RBG-46968

SUBJECT: Supplement to Requests for Relief from ASME Section XI Volumetric and Visual Examination Requirements – Second 10-Year Interval
River Bend Station
Docket No. 50-458
License No. NPF-47

**Additional Information for Request for Relief
RBS-ISI-007, RBS-ISI-008, RBS-ISI-009, RBS-ISI-010 and RBS-ISI-011**

REV.:		DATE: 3-11-88	DRAWN: CA6	CHK'D: JS	APPR.: JBB	DATE: 3-5-88	DWG. NO. RBS-ISI-022	REACTOR PRESSURE VESSEL
							SEAM JOINT ID, NOZZLE LOCATION & WELD MAP

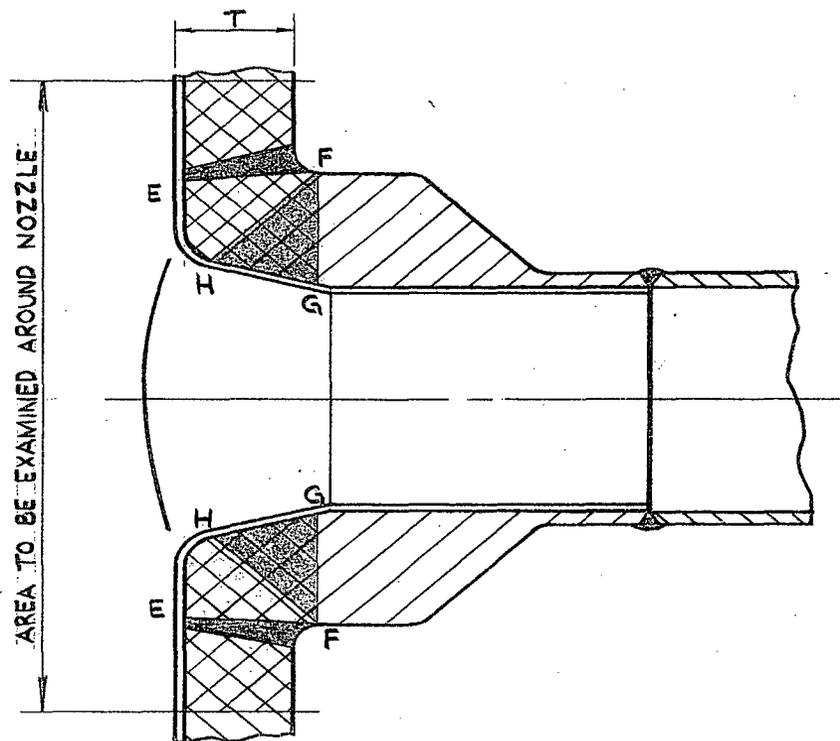
RBS-ISI-008, B-D Examinations				
Item Number	Item ID	Item Description	% Coverage	Response to NRC Questions
B3.90	N03A-1	24" Main Steam, RPV Nozzle to Shell	50.0%	a) Scanning is limited to single side access due to nozzle configuration. Scanned from vessel side only. See attached sketches of nozzle locations and scan coverage. b) Weld scanned manually with KBA search unit and Staveley Sonic 136 instrument. 100% of the ASME Code Required Volume cannot be examined using manual examination methods. No alternative NDE methods or advanced technologies could be practically employed to maximize ASME Code coverage. c) Modality – Shear and longitudinal. Insonification angles - 0°L, 45°S and 60°S. d) See attached Examination Coverage Profile showing the Code Required Volume (CRV). e) Surface examination <u>not</u> required. f) No relevant indications recorded.
B3.90	N03B-1	24" Main Steam, RPV Nozzle to Shell	50.0%	a) Scanning is limited to single side access due to nozzle configuration. Scanned from vessel side only. See attached sketches of nozzle locations and scan coverage. b) Weld scanned manually with KBA search unit and Staveley Sonic 136 instrument. 100% of the ASME Code Required Volume cannot be examined using manual examination methods. No alternative NDE methods or advanced technologies could be practically employed to maximize ASME Code coverage. c) Modality – Shear and longitudinal. Insonification angles - 0°L, 45°S and 60°S. d) See attached Examination Coverage Profile showing the Code Required Volume (CRV). e) Surface examination <u>not</u> required. f) No relevant indications recorded.

B3.90	N03C-1	24" Main Steam, RPV Nozzle to Shell	50.0%	a) Scanning is limited to single side access due to nozzle configuration. Scanned from vessel side only. See attached sketches of nozzle locations and scan coverage. b) Weld scanned manually with KBA search unit and Staveley Sonic 136 instrument. 100% of the ASME Code Required Volume cannot be examined using manual examination methods. No alternative NDE methods or advanced technologies could be practically employed to maximize ASME Code coverage. c) Modality – Shear and longitudinal. Insonification angles - 0°L, 45°S and 60°S. d) See attached Examination Coverage Profile showing the Code Required Volume (CRV). e) Surface examination <u>not</u> required. f) No relevant indications recorded.

RBS-ISI-008, B-D Examinations				
Item Number	Item ID	Item Description	% Coverage	Response to NRC Questions
B3.90	N03D-1	24" Main Steam, RPV Nozzle to Shell	50.0%	a) Scanning is limited to single side access due to nozzle configuration. Scanned from vessel side only. See attached sketches of nozzle locations and scan coverage. b) Weld scanned manually with KBA search unit and Staveley Sonic 136 instrument. 100% of the ASME Code Required Volume cannot be examined using manual examination methods. No alternative NDE methods or advanced technologies could be practically employed to maximize ASME Code coverage. c) Modality – Shear and longitudinal. Insonification angles - 0°L, 45°S and 60°S. d) See attached Examination Coverage Profile showing the Code Required Volume (CRV). e) Surface examination <u>not</u> required. f) No relevant indications recorded.
B3.90	N16-1	12" RCS Inlet Nozzle to Vessel	50.0%	a) Scanning is limited to single side access due to nozzle configuration. Scanned from vessel side only. See attached sketches of nozzle locations, configurations and scan coverage. b) Weld scanned manually with KBA search unit and Staveley Sonic 136 instrument. 100% of the ASME Code Required Volume cannot be examined using manual examination methods. No alternative NDE methods or advanced technologies could be practically employed to maximize ASME Code coverage. c) Modality – Shear and longitudinal. Insonification angles - 0°L, 45°S and 60°S. d) See attached Examination Coverage Profile showing the Code Required Volume (CRV). e) Surface examination <u>not</u> required. f) No relevant indications recorded.

B3.90	N04A-1	12" Feedwater Nozzle to Vessel	50.0%	a) Scanning is limited to single side access due to nozzle configuration. Scanned from vessel side only. See attached sketches of nozzle locations, configurations and scan coverage. b) Weld scanned manually with KBA search unit and Staveley Sonic 136 instrument. 100% of the ASME Code Required Volume cannot be examined using manual examination methods. No alternative NDE methods or advanced technologies could be practically employed to maximize ASME Code coverage. c) Modality – Shear and longitudinal. Insonification angles - 0°L, 45°S and 60°S. d) See attached Examination Coverage Profile showing the Code Required Volume (CRV). e) Surface examination <u>not</u> required. f) No relevant indications recorded.

B13-D001 N02A-1 through N02K-1
NOZZLE-TO-VESSEL CONFIGURATION AND EXAMINATION LIMITATIONS

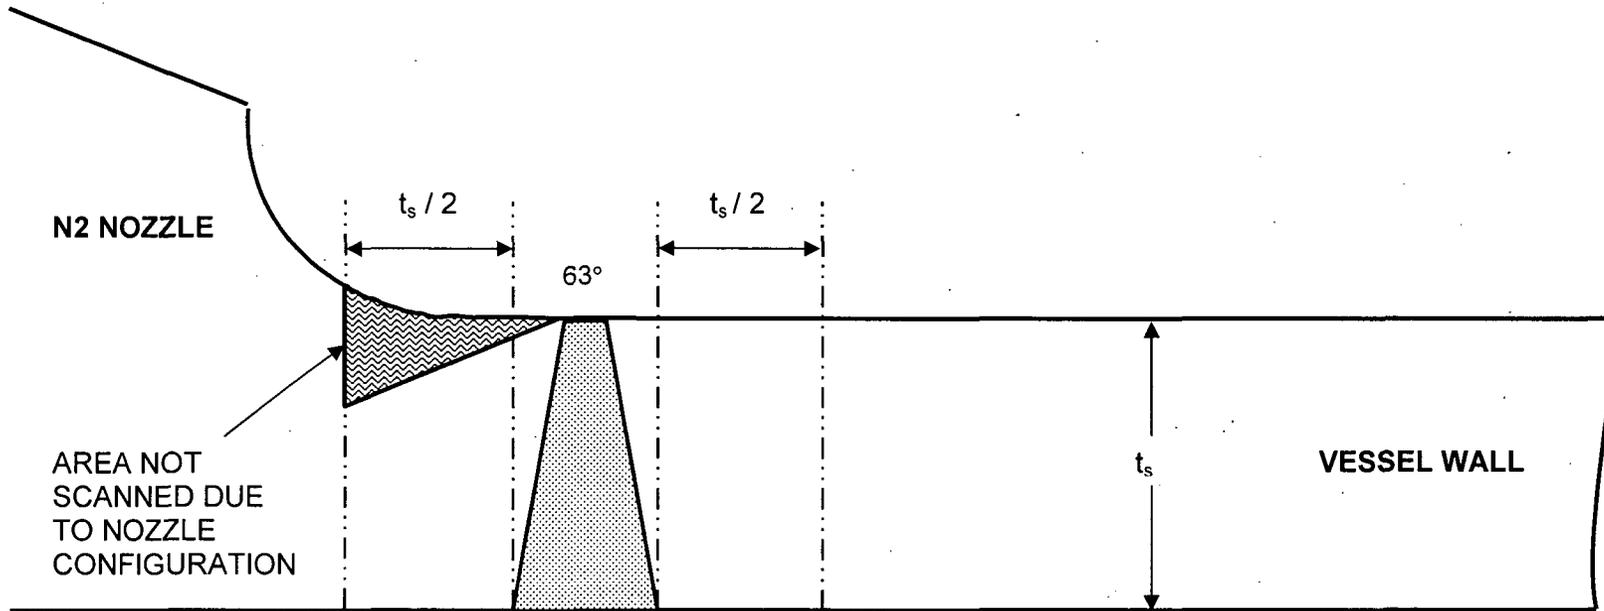
RBS-ISI-008, B-D Examinations				
Item Number	Item ID	Item Description	% Coverage	Response to NRC Questions
B3.90	N02A-1	10" RCS Inlet Nozzle to Vessel	85.0%	a) Scanning is limited to single side access due to close proximity of nozzle transition. See attached sketches of nozzle locations, configurations and scan coverage. b) Weld scanned manually with Krautkramer and RTD search units and Staveley Sonic 136 and Krautkramer instruments. 100% of the ASME Code Required Volume cannot be examined using manual examination methods. No alternative NDE methods or advanced technologies could be practically employed to maximize ASME Code coverage. Examination performed to App. VIII requirements with Appendix VIII qualified procedures. c) Modality – Shear and longitudinal. Insonification angles - 35°S, 50°S and 60°RL. d) See attached Examination Coverage Profile showing the Code Required Volume (CRV). e) Surface examination <u>not</u> required. f) No relevant indications recorded.

B3.90	N02B-1	10" RCS Inlet Nozzle to Vessel	85.0%	a) Scanning is limited to single side access due to close proximity of nozzle transition. See attached sketches of nozzle locations, configurations and scan coverage. b) Weld scanned manually with Krautkramer and RTD search units and Staveley Sonic 136 and Krautkramer instruments. 100% of the ASME Code Required Volume cannot be examined using manual examination methods. No alternative NDE methods or advanced technologies could be practically employed to maximize ASME Code coverage. Examination performed to App. VIII requirements with Appendix VIII qualified procedures. c) Modality – Shear and longitudinal. Insonification angles - 35°S, 50°S and 60°RL. d) See attached Examination Coverage Profile showing the Code Required Volume (CRV). e) Surface examination <u>not</u> required. f) No relevant indications recorded.
B3.90	N02C-1	10" RCS Inlet Nozzle to Vessel	79.0%	a) Scanning is limited to single side access due to close proximity of nozzle transition. This nozzle also has additional limitation due to proximity of the N9 nozzle. See attached sketches of nozzle locations, configurations and scan coverage. b) Weld scanned manually with Krautkramer and RTD search units and Staveley Sonic 136 and Krautkramer instruments. 100% of the ASME Code Required Volume cannot be examined using manual examination methods. No alternative NDE methods or advanced technologies could be practically employed to maximize ASME Code coverage. Examination performed to App. VIII requirements with Appendix VIII qualified procedures. c) Modality – Shear and longitudinal. Insonification angles - 35°S, 50°S and 60°RL. d) See attached Examination Coverage Profile showing the Code Required Volume (CRV). e) Surface examination <u>not</u> required. f) No relevant indications recorded.

RBS-ISI-008, B-D Examinations				
Item Number	Item ID	Item Description	% Coverage	Response to NRC Questions
B3.90	N02D-1	10" RCS Inlet Nozzle to Vessel	79.0%	a) Scanning is limited to single side access due to close proximity of nozzle transition. This nozzle also has additional limitation due to proximity of the N9 nozzle. See attached sketches of nozzle locations, configurations and scan coverage. b) Weld scanned manually with Krautkramer and RTD search units and Staveley Sonic 136 and Krautkramer instruments. 100% of the ASME Code Required Volume cannot be examined using manual examination methods. No alternative NDE methods or advanced technologies could be practically employed to maximize ASME Code coverage. Examination performed to App. VIII requirements with Appendix VIII qualified procedures. c) Modality – Shear and longitudinal. Insonification angles - 35°S, 50°S and 60°RL. d) See attached Examination Coverage Profile showing the Code Required Volume (CRV). e) Surface examination <u>not</u> required. f) No relevant indications recorded.

B3.90	N02E-1	10" RCS Inlet Nozzle to Vessel	85.0%	a) Scanning is limited to single side access due to close proximity of nozzle transition. See attached sketches of nozzle locations, configurations and scan coverage. b) Weld scanned manually with Krautkramer and RTD search units and Staveley Sonic 136 and Krautkramer instruments. 100% of the ASME Code Required Volume cannot be examined using manual examination methods. No alternative NDE methods or advanced technologies could be practically employed to maximize ASME Code coverage. Examination performed to App. VIII requirements with Appendix VIII qualified procedures. c) Modality – Shear and longitudinal. Insonification angles - 35°S, 50°S and 60°RL. d) See attached Examination Coverage Profile showing the Code Required Volume (CRV). e) Surface examination <u>not</u> required. f) No relevant indications recorded.
B3.90	N02F-1	10" RCS Inlet Nozzle to Vessel	85.0%	a) Scanning is limited to single side access due to close proximity of nozzle transition. See attached sketches of nozzle locations, configurations and scan coverage. b) Weld scanned manually with Krautkramer and RTD search units and Staveley Sonic 136 and Krautkramer instruments. 100% of the ASME Code Required Volume cannot be examined using manual examination methods. No alternative NDE methods or advanced technologies could be practically employed to maximize ASME Code coverage. Examination performed to App. VIII requirements with Appendix VIII qualified procedures. c) Modality – Shear and longitudinal. Insonification angles - 35°S, 50°S and 60°RL. d) See attached Examination Coverage Profile showing the Code Required Volume (CRV). e) Surface examination <u>not</u> required. f) No relevant indications recorded.

RBS-ISI-008, B-D Examinations				
Item Number	Item ID	Item Description	% Coverage	Response to NRC Questions
B3.90	N02G-1	10" RCS Inlet Nozzle to Vessel	85.0%	a) Scanning is limited to single side access due to close proximity of nozzle transition. See attached sketches of nozzle locations, configurations and scan coverage. b) Weld scanned manually with Krautkramer and RTD search units and Staveley Sonic 136 and Krautkramer instruments. 100% of the ASME Code Required Volume cannot be examined using manual examination methods. No alternative NDE methods or advanced technologies could be practically employed to maximize ASME Code coverage. Examination performed to App. VIII requirements with Appendix VIII qualified procedures. c) Modality – Shear and longitudinal. Insonification angles - 35°S, 50°S and 60°RL. d) See attached Examination Coverage Profile showing the Code Required Volume (CRV). e) Surface examination <u>not</u> required. f) No relevant indications recorded.

B3.90	N02H-1	10" RCS Inlet Nozzle to Vessel	79.0%	a) Scanning is limited to single side access due to close proximity of nozzle transition. This nozzle also has additional limitation due to proximity of the N9 nozzle. See attached sketches of nozzle locations, configurations and scan coverage. b) Weld scanned manually with Krautkramer and RTD search units and Staveley Sonic 136 and Krautkramer instruments. 100% of the ASME Code Required Volume cannot be examined using manual examination methods. No alternative NDE methods or advanced technologies could be practically employed to maximize ASME Code coverage. Examination performed to App. VIII requirements with Appendix VIII qualified procedures. c) Modality – Shear and longitudinal. Insonification angles - 35°S, 50°S and 60°RL. d) See attached Examination Coverage Profile showing the Code Required Volume (CRV). e) Surface examination <u>not</u> required. f) No relevant indications recorded.

B3.90	N02J-1	10" RCS Inlet Nozzle to Vessel	79.0%	a) Scanning is limited to single side access due to close proximity of nozzle transition. This nozzle also has additional limitation due to proximity of the N9 nozzle. See attached sketches of nozzle locations, configurations and scan coverage. b) Weld scanned manually with Krautkramer and RTD search units and Staveley Sonic 136 and Krautkramer instruments. 100% of the ASME Code Required Volume cannot be examined using manual examination methods. No alternative NDE methods or advanced technologies could be practically employed to maximize ASME Code coverage. Examination performed to App. VIII requirements with Appendix VIII qualified procedures. c) Modality – Shear and longitudinal. Insonification angles - 35°S, 50°S and 60°RL. d) See attached Examination Coverage Profile showing the Code Required Volume (CRV). e) Surface examination <u>not</u> required. f) No relevant indications recorded.

RBS-ISI-008, B-D Examinations				
Item Number	Item ID	Item Description	% Coverage	Response to NRC Questions
B3.90	N02K-1	10" RCS Inlet Nozzle to Vessel	85.0%	a) Scanning is limited to single side access due to close proximity of nozzle transition. See attached sketches of nozzle locations, configurations and scan coverage. b) Weld scanned manually with Krautkramer and RTD search units and Staveley Sonic 136 and Krautkramer instruments. 100% of the ASME Code Required Volume cannot be examined using manual examination methods. No alternative NDE methods or advanced technologies could be practically employed to maximize ASME Code coverage. Examination performed to App. VIII requirements with Appendix VIII qualified procedures. c) Modality – Shear and longitudinal. Insonification angles - 35°S, 50°S and 60°RL. d) See attached Examination Coverage Profile showing the Code Required Volume (CRV). e) Surface examination <u>not</u> required. f) No relevant indications recorded.

REACTOR PRESSURE VESSEL FLANGE THREADS GENERAL CONFIGURATION AND NUMBERING ARRANGEMENT

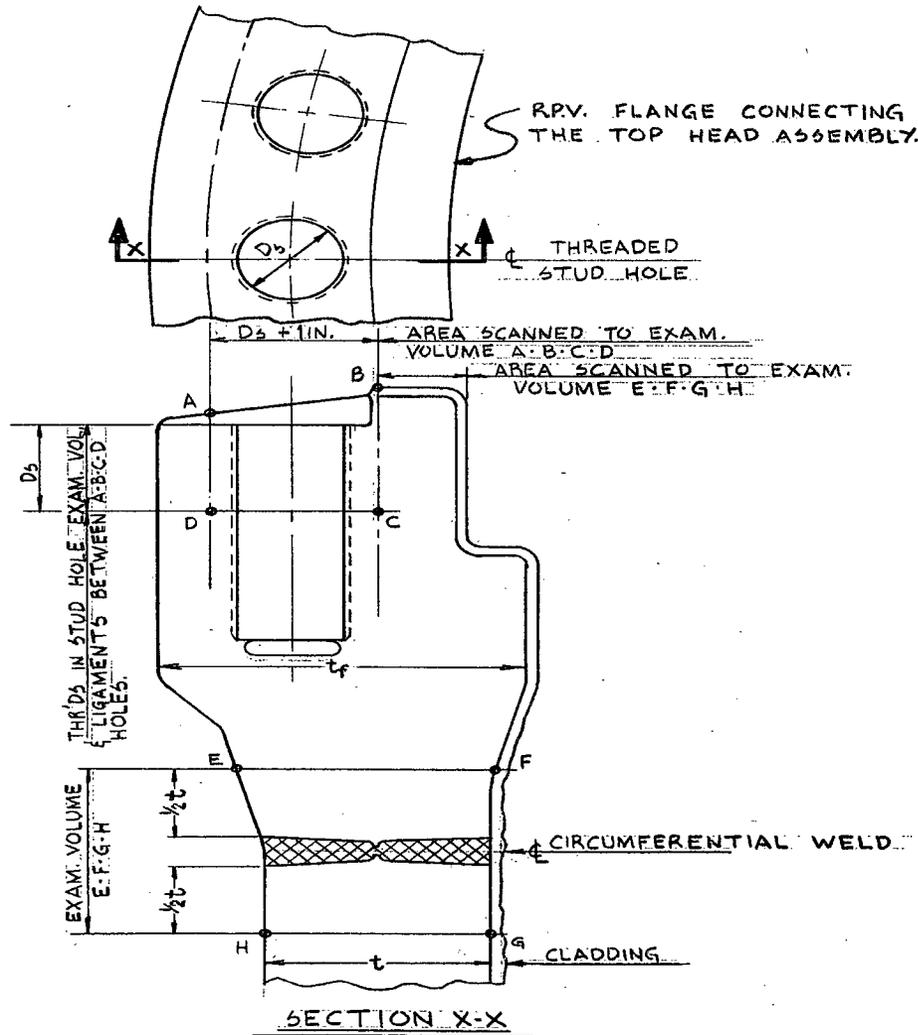
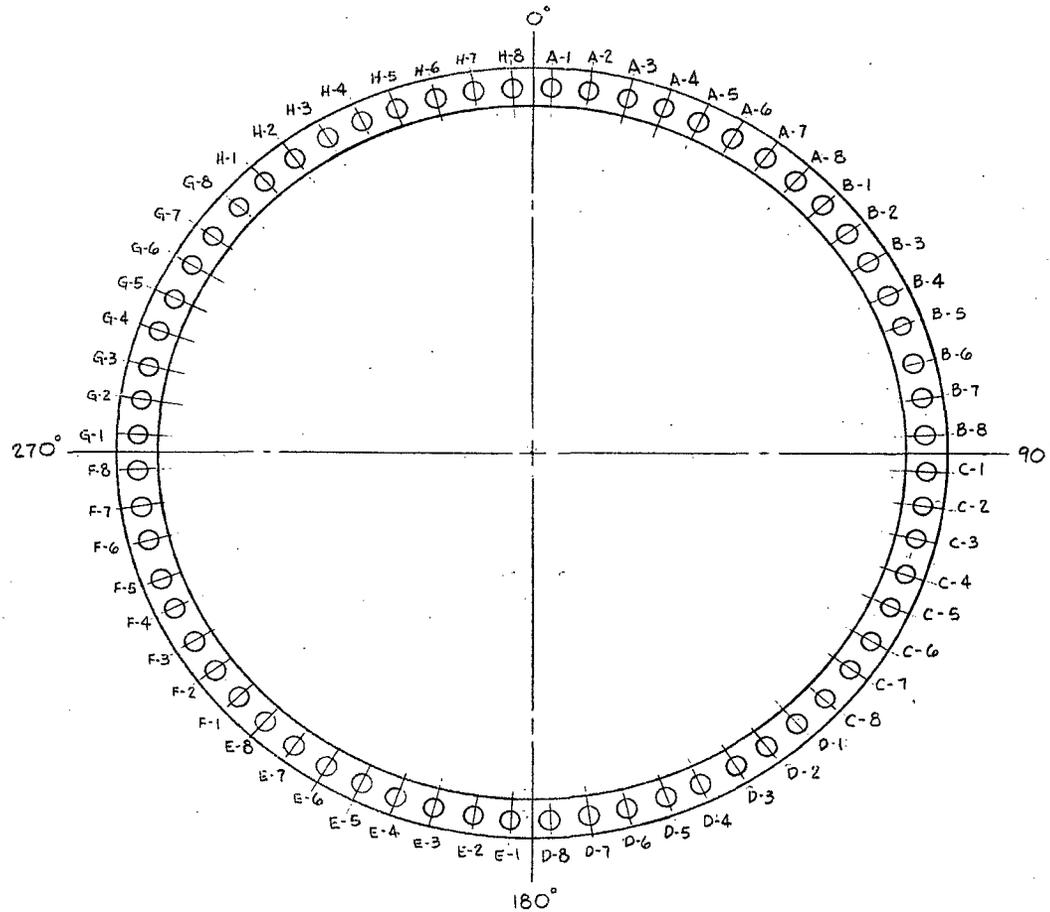
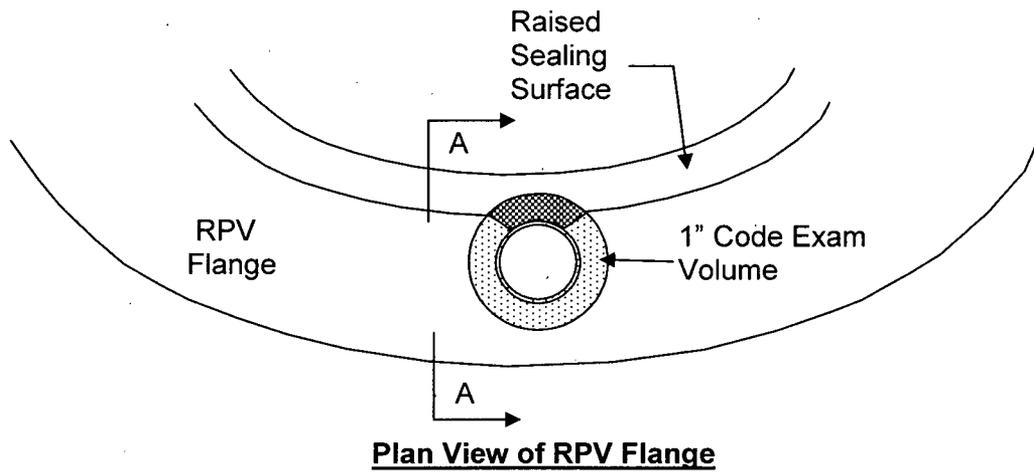
RBS-ISI-009, B – G - 1 Examinations				
Item Number	Item ID	Item Description	% Coverage	Response to NRC Questions
B6.40	FLG LIG A1-A8 through FLG LIG H1-H8	Reactor Vessel Threads-in-Flange	87%	<ul style="list-style-type: none"> a) Scanning obstructed between 333° and 27° at each stud hole location due to raised seal face configuration. See attached sketches of flange stud hole locations, configurations and scan coverage. b) Subject area scanned manually with Staveley and KBA search units and Krautkramer, Staveley and Panametrics instruments. 100% of the ASME Code Required Volume cannot be examined using manual examination methods. No alternative NDE methods or advanced technologies could be practically employed to maximize ASME Code coverage. c) Modality – longitudinal. Insonification angle - 0°L. d) See attached Examination Coverage Profile showing the Code Required Volume (CRV). e) Surface examination not required. f) No relevant indications recorded.

RCS-900B-FWB06
PUMP-TO-PIPE CONFIGURATION AND EXAMINATION COVERAGE

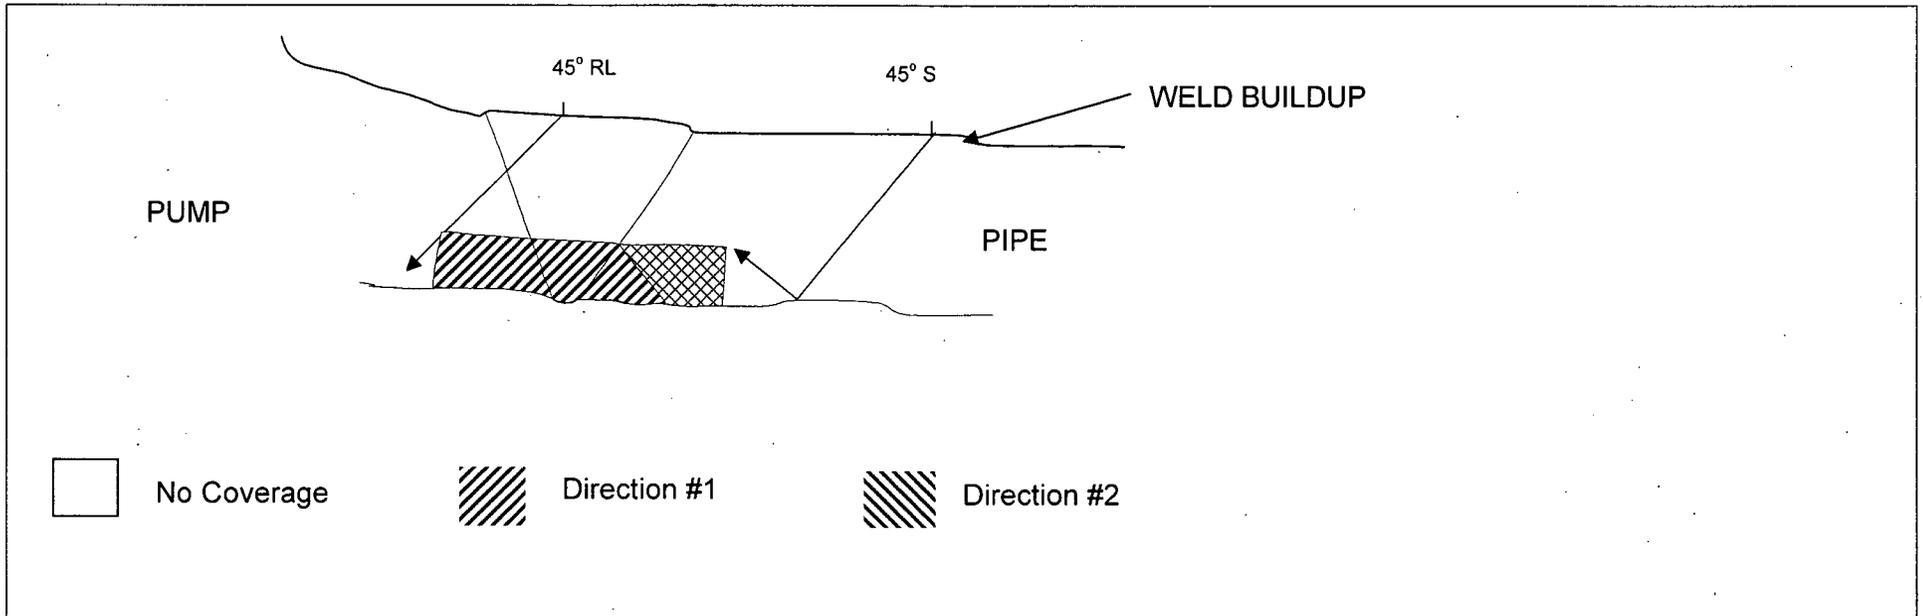
Item Number	Item ID	Item Description	% Coverage	Response to NRC Questions
B9.11	RCS-900B-FWB06	RCS pump to 20" Pipe, SS	80.7%	a) Scanning from pipe side only of pipe-to-pump weld configuration. See attached sketches of configurations and scan coverage. b) Subject area scanned manually with KBA and RTD search units and Staveley instruments. 100% of the ASME Code Required Volume cannot be examined using manual examination methods. No alternative NDE methods or advanced technologies could be practically employed to maximize ASME Code coverage. Examination performed prior to PDI implementation. c) Modality – Shear and longitudinal. Insonification angles - 45°S and 60°RL. 45°RL used for axial and circ scans due to overlay. d) See attached Examination Coverage Profile showing the Code Required Volume (CRV). e) Surface examination performed with full code coverage. f) No relevant indications recorded.
